Access Compliance Report

Public Rights-of-Way

Intersection ID: 32271	Main Street: SPRINGWELL_ST	Cross Street: SULLIVAN_RIDGE_DR	Location: NE
ADA ID: 1E3801D8CDFB	Ramp Type: PerpDiag	Initial Pass/Fail: Fail	Overall Compliance: No
Severity Score: 21.25			
Codes/Mitigation Info/Possible Solution		Field Measurements/Component Compliance

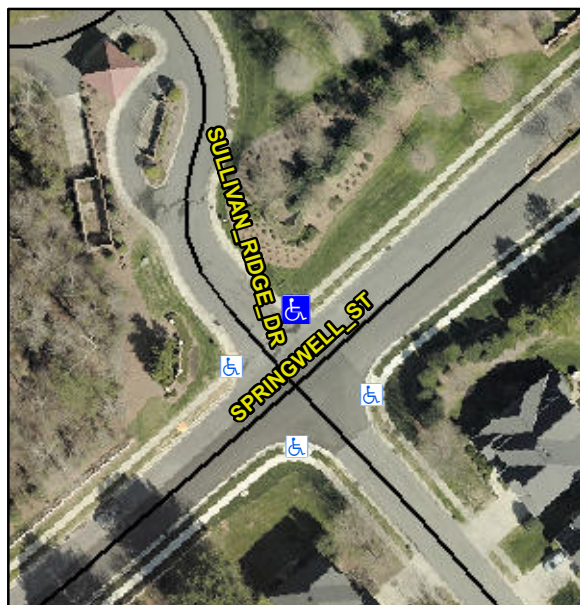
Not Found, R304.5.1, R304.2.2

Compliance	Description	Data	Compliance	Description	Data
N/A	Ramp Length (in)	59.0	No	Ramp Slope (%)	11.9
No	Ramp Width (in)	42.0	Yes	Ramp XSlope (%)	1.7
N/A	Flare Type LT	N/A	N/A	Flare Type RT	N/A
N/A	Flare Slope LT (%)	N/A	N/A	Flare Slope RT (%)	N/A
N/A	Flare Traversable LT?	N/A	N/A	Flare Traversable RT?	N/A
N/A	Landing Length (in)	N/A	N/A	DWS Provided?	N/A
N/A	Landing Width (in)	N/A	N/A	DWS Contrast?	N/A
N/A	Landing Slope (%)	N/A	N/A	DWS Length (in)	N/A
N/A	Landing X Slope (%)	N/A	N/A	DWS Full Width?	N/A
N/A	Landing Curb? (Y/N)	N/A	N/A	DWS Offset (in)	N/A
N/A	Shared Landing?	N/A			
N/A	Gutter Ponding?	N/A	N/A	Gutter Slope (%)	N/A
N/A	Gutter Lip Ht (in)	N/A	N/A	Gutter X Slope (%)	N/A
N/A	Painted X Walk1?	No	N/A	Painted X Walk2?	No
	X Walk 1 Direction	To SW		X Walk 2 Direction	To SE
N/A	X Walk 1 Width (in)	N/A	N/A	X Walk 2 Width (in)	N/A
	X Walk 1 Slope (%)	5.1		X Walk 2 Slope (%)	2.1
	X Walk 1 X Slope (%)	0.5		X Walk 2 X Slope (%)	5.6

N/A	Ramp inside XWalk1?	N/A	N/A	Ramp inside XWalk2?	N/A
	Road Slope (%)	2.3	N/A	Clear Space?	N/A
	Road X Slope (%)	6.0	N/A	Clear Space to XWalk (in)	N/A
N/A	Any Obstructions?	N/A	N/A	Storm Grate/Utility Hazard?	N/A
	Obstruction Type			Storm Grate/Utility Type	
		N/A			N/A
		Yes		Surface Condition? (G/P)	Good

Remove & Replace Curb Ramp With Two New Directional Ramps or Equivalent.
